Office Action Summary	Application No. 10/572,506	Applicant(s) JEON ET AL.	
	Examiner Kwang Han	Art Unit 1727

LITHIUM ION SECONDARY BATTERY HAVING ENHANCED WELDABILITY AND SEALING CAPABILITY

Examiner: K. Han SN: 10/572,506 Art Unit: 1727 October 26, 2010

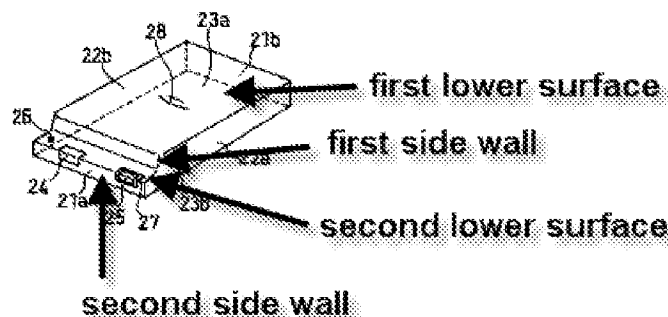
Regarding claims 4 and 18, Murashige discloses a lithium ion secondary battery [Abstract] comprised of a can with an opening at an upper portion (Drawing 4), where the upper end of the can has a two-stage step formed with a first lower surface, first side wall extended upwardly from the first lower surface, a second lower surface located higher than the first lower surface while being extended outwardly from the first side wall, and a second side wall extended upwardly from the second lower surface as shown in the figure below (Drawing 2);

a cover (31, cap) having a contact surface facing the flange of the can and the cap not inserted into the can (Drawing 5), an electrode assembly (33) located on the first lower surface [0023], a protruded terminal (24, 25) through the second lower surface located

close to the first side wall of the can, and the can is welded to form a seal [0013] but does not explicitly teach the use of micro-arc welding or the use of a flange extended outwardly from an upper end of the can.
